**From:** [Chris Holm](#)  
**To:** ["Angel Anguiano"](#)  
**Cc:** [Zarah Lacson](#)  
**Subject:** P18-007 comments summary  
**Date:** Friday, July 20, 2018 3:06:00 PM  
**Attachments:** [Decatur, GA Starbucks interior drive-through lane - Site plan.pdf](#)  
[Decatur, GA Starbucks interior drive-through lane - Aerial.pdf](#)  
[Decatur, GA Starbucks interior drive-through lane - Street view.pdf](#)  
[Coffee Kiosk path of travel.pdf](#)

Here's some comments on the Stockton and Fruitridge Shopping Center project.

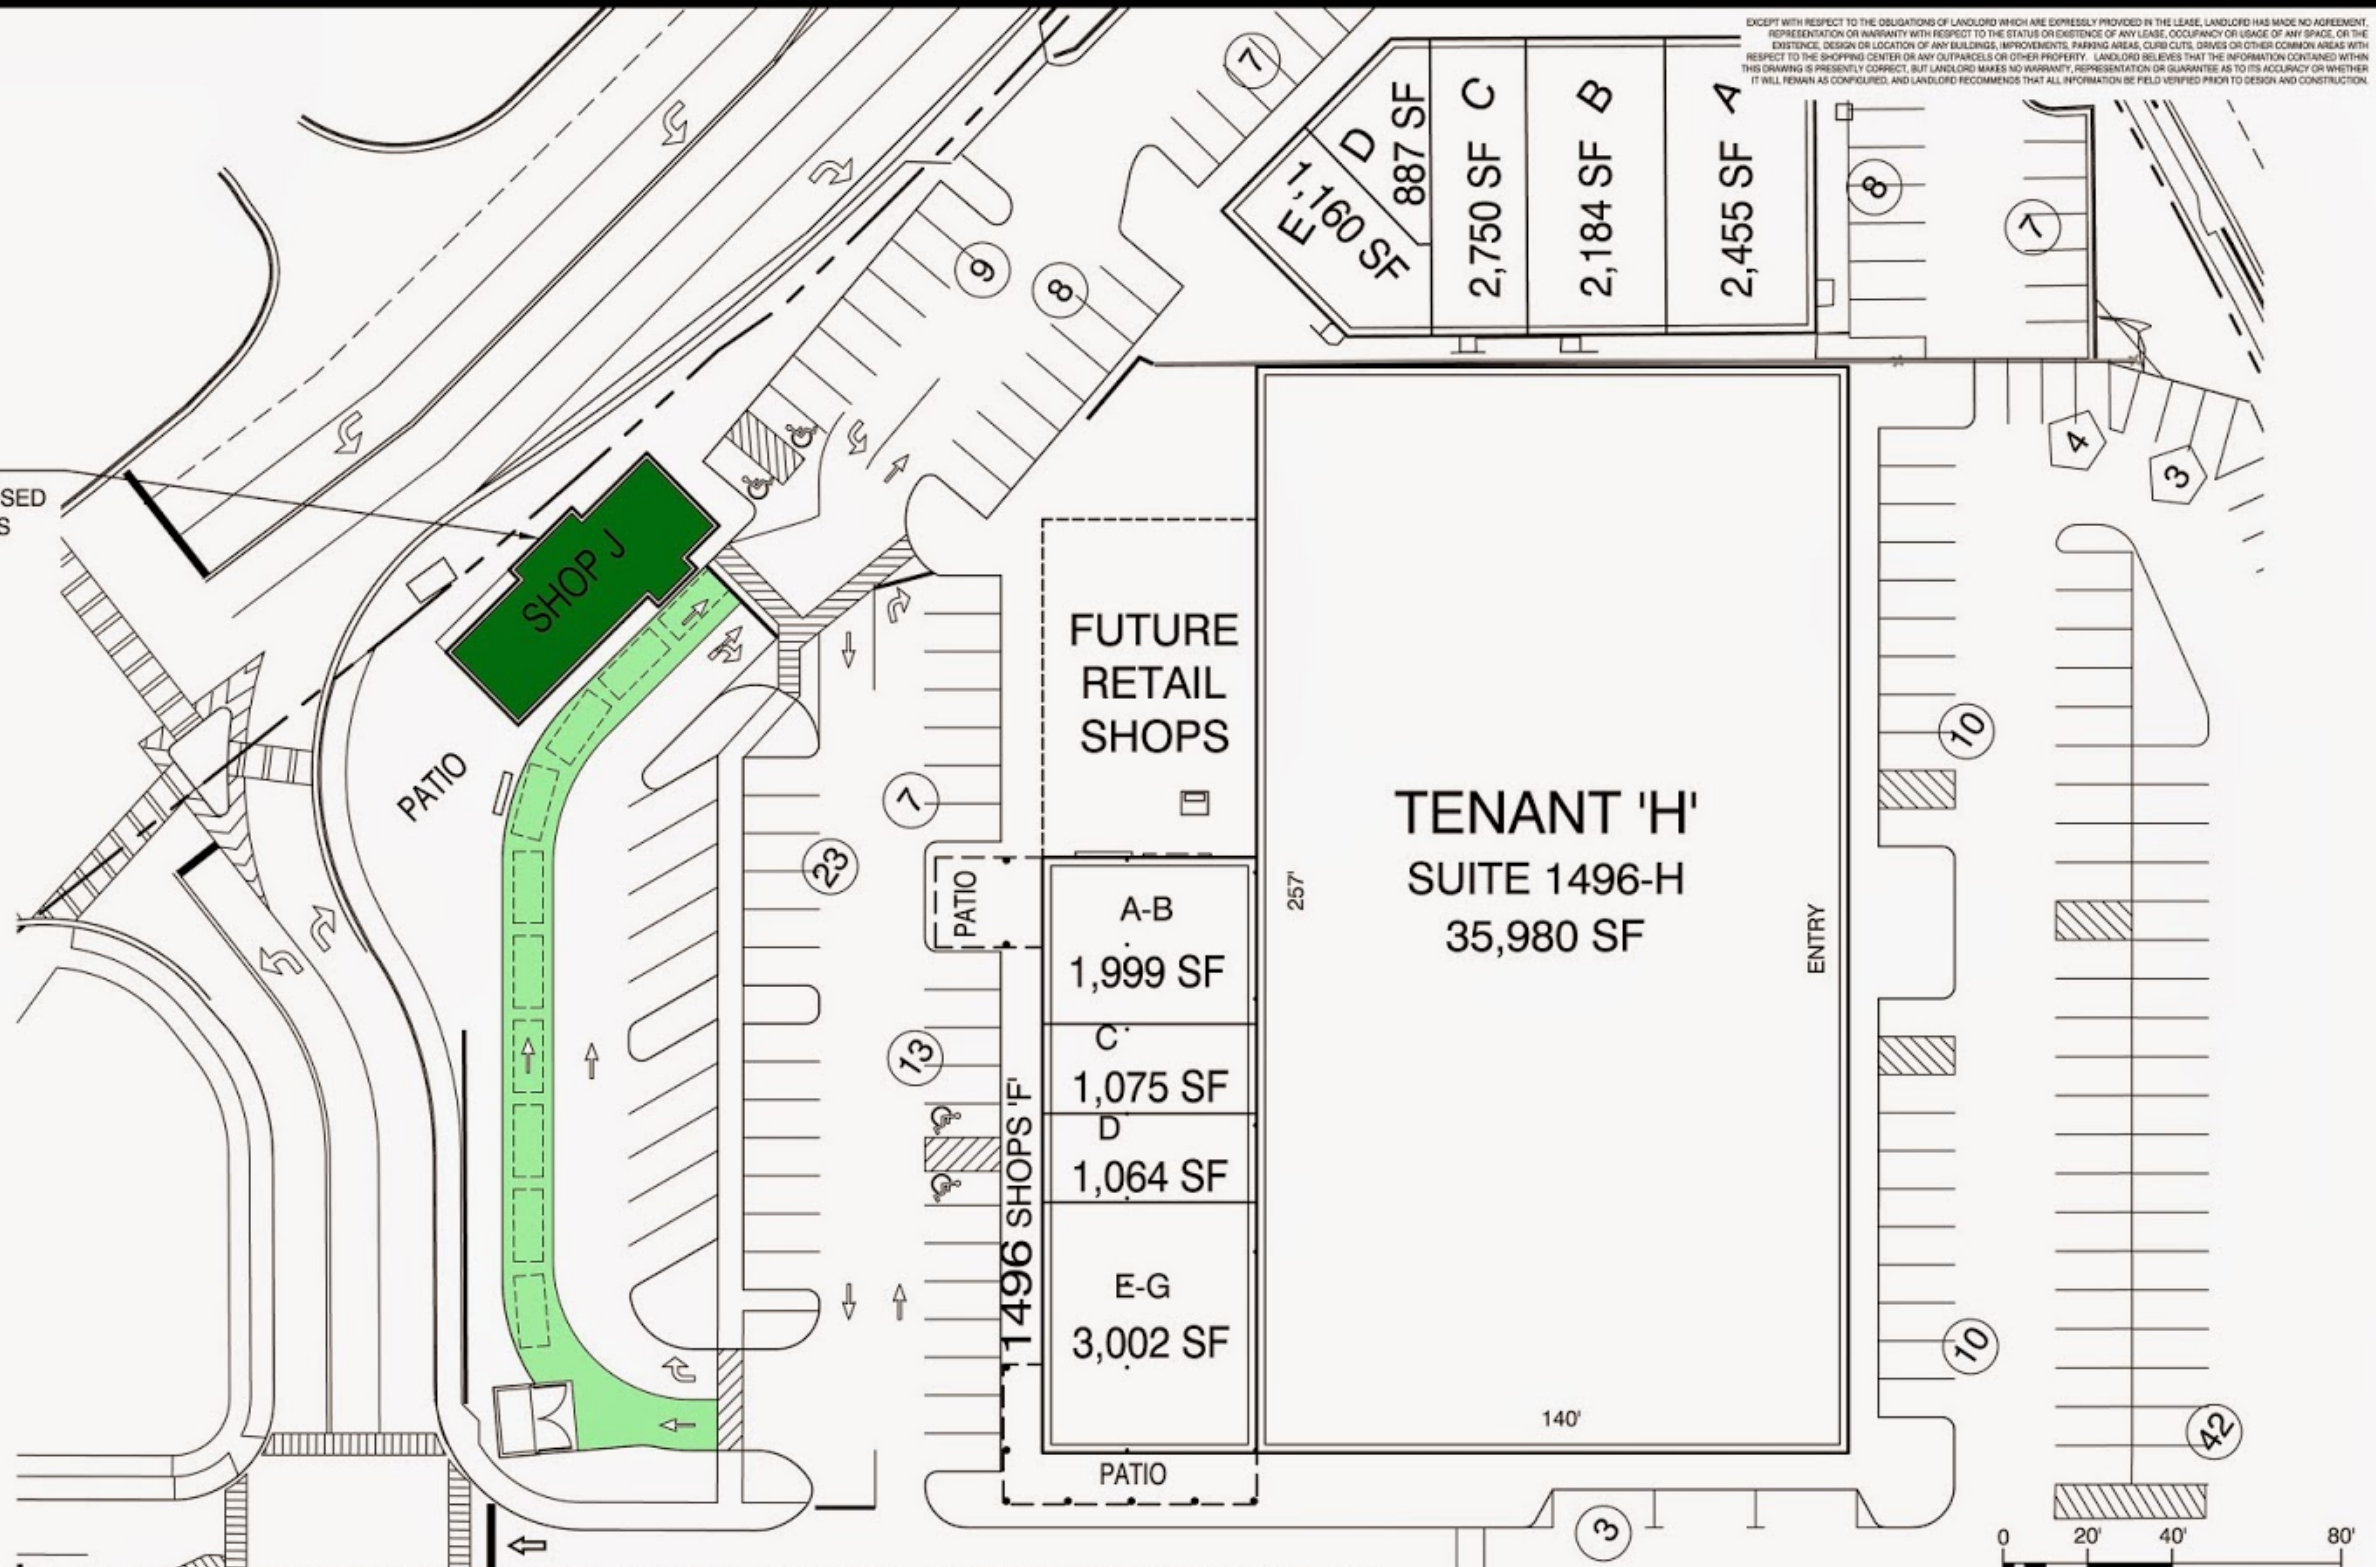
The new coffee kiosk on Pad H lies within the pedestrian desire line between the front sidewalks of Building E and Building F. The crosswalk at the drive-through exit is in the middle of the space that will be taken by a vehicle waiting to exit the drive-through and enter the parking lot drive

aisle. We recommend moving the kiosk building, crosswalk and the sidewalks back so the path of travel is straight. See the attached drawing.

The crosswalk between Building E and Building F is indirect, while the existing crosswalk takes the desire line between the buildings. Landscaping could realign the desire line while still providing the curb ramp to the parking along the side of Building F.

# SUBURBAN PLAZA REDEVELOPMENT: SHOP J ALTERNATE LOCATION PLAN

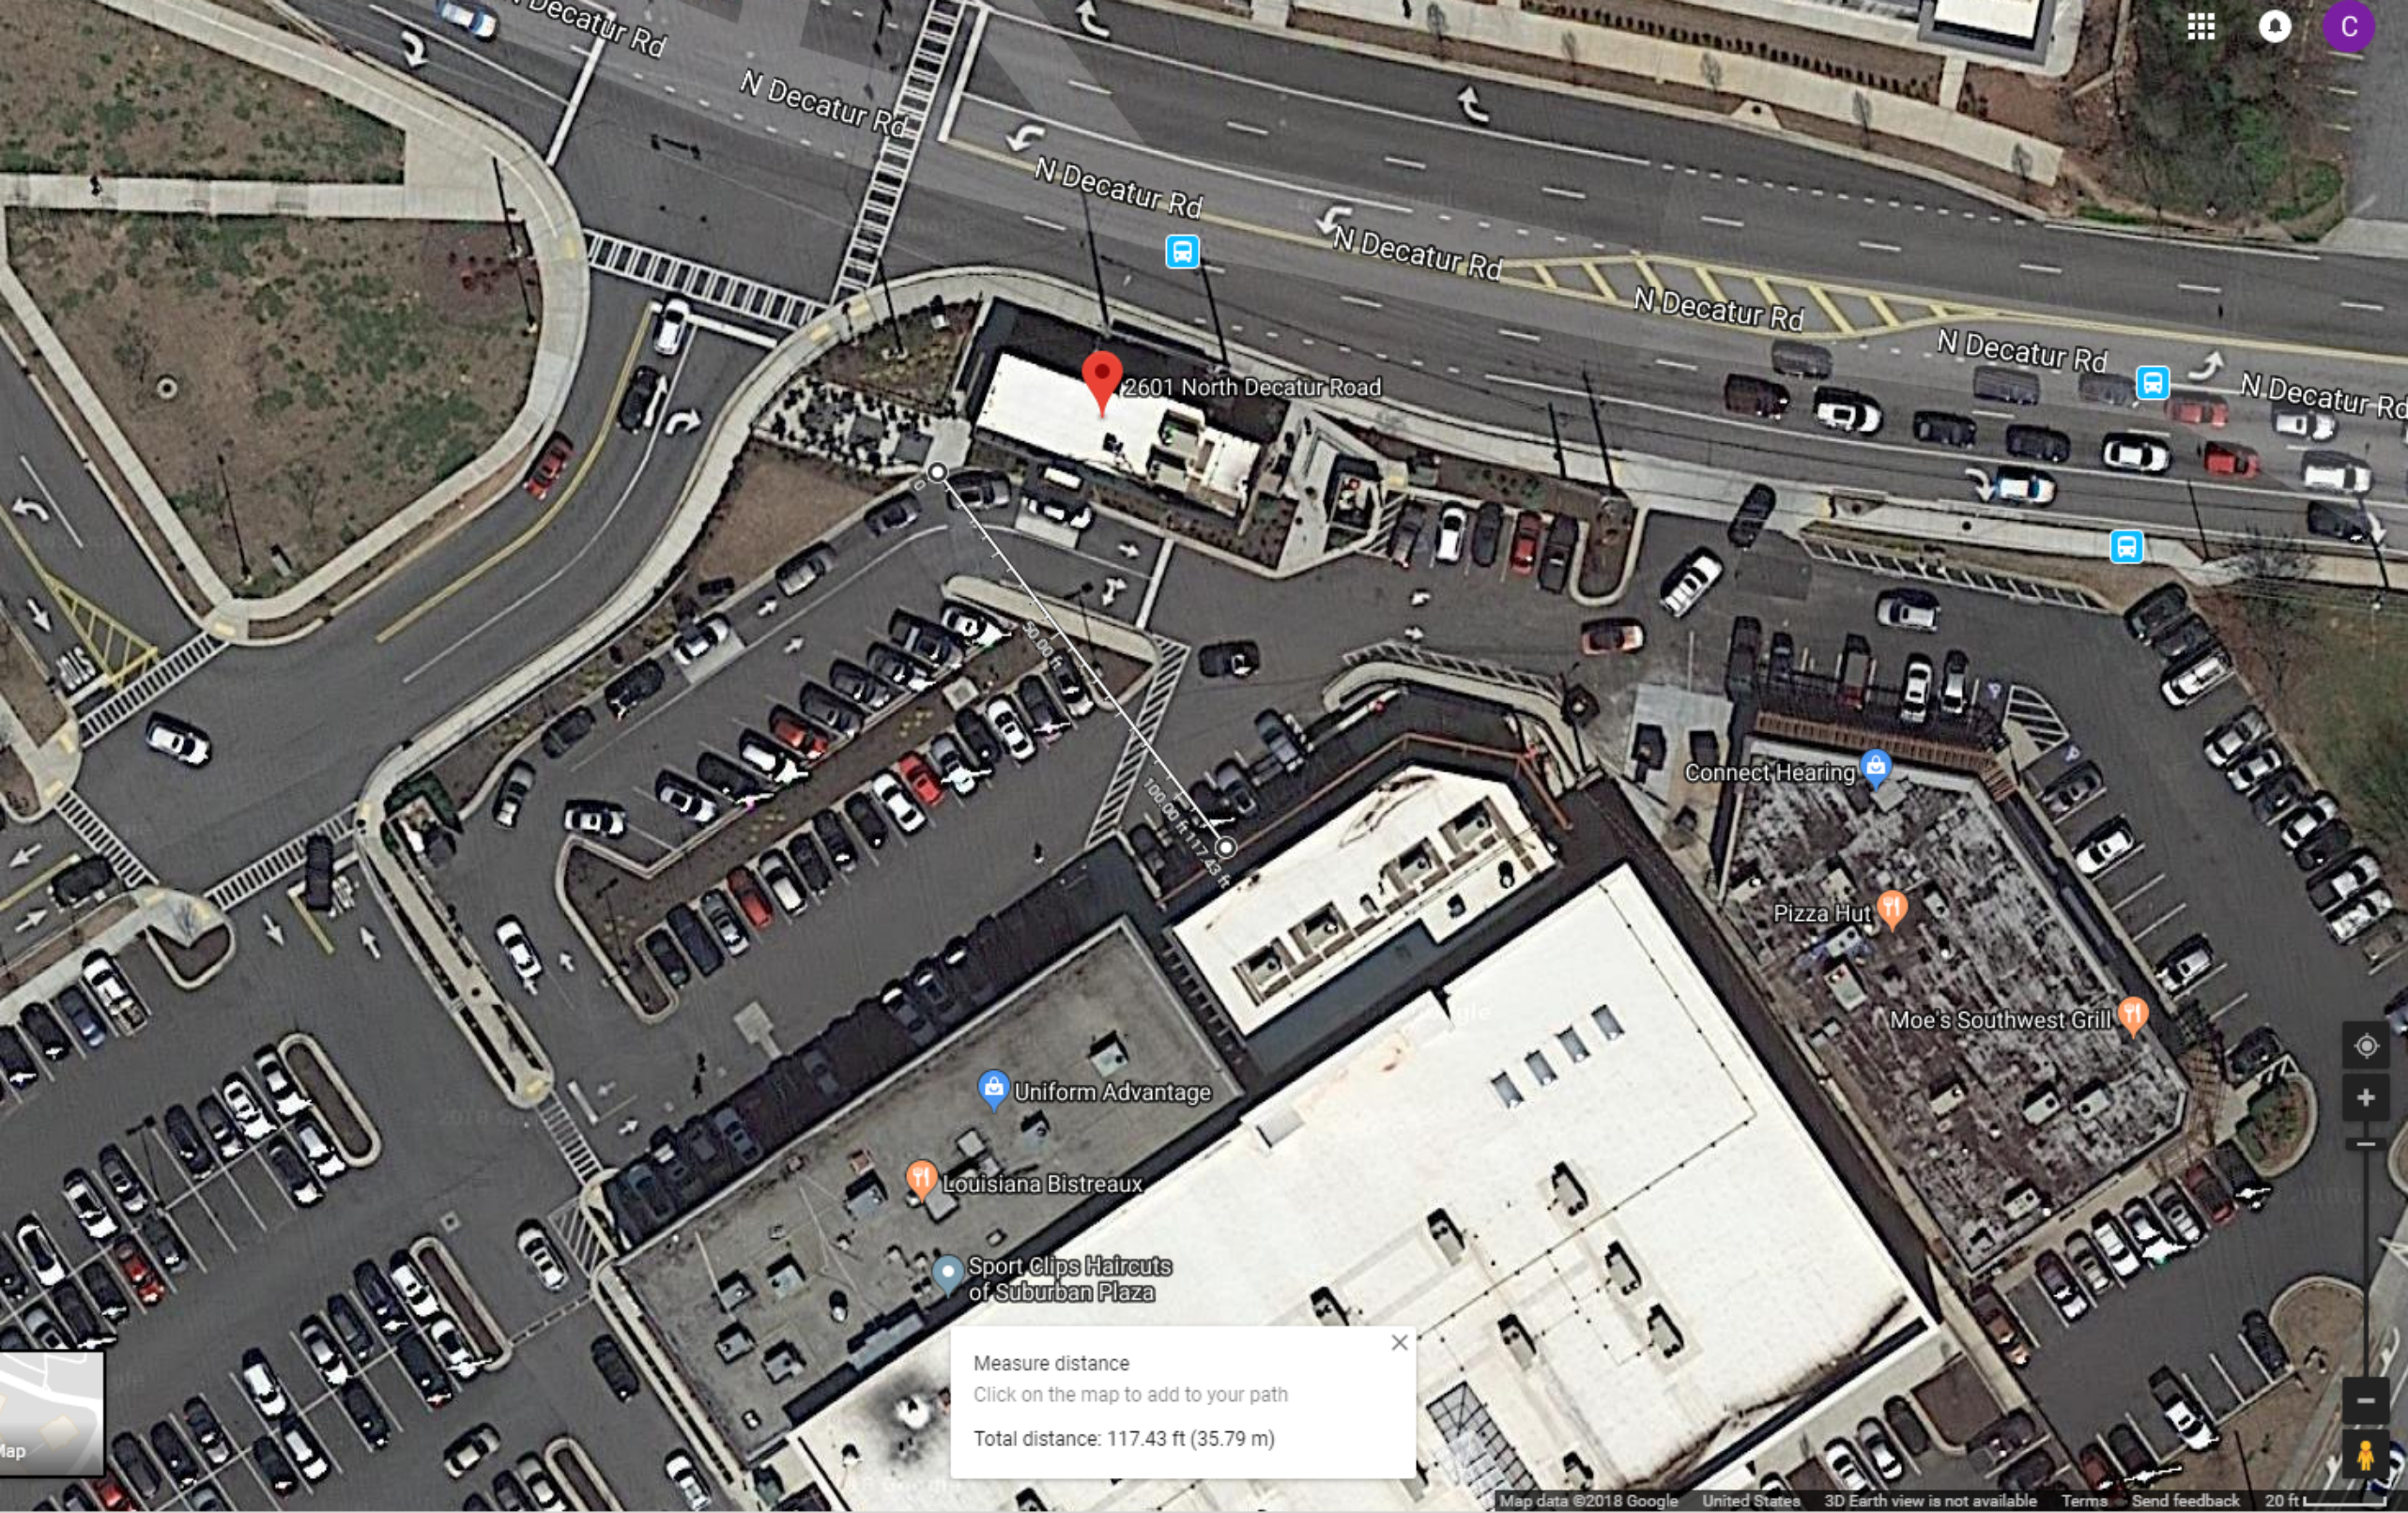
The Starbucks should welcome pedestrians from the corner with an active front or corner facing the intersection with the drive-through lane in between. See the attached site plan and Google views for a similar corner (2601 North Decatur Road, Decatur, GA). What they built is even better than what was in the proposed alternate site plan.
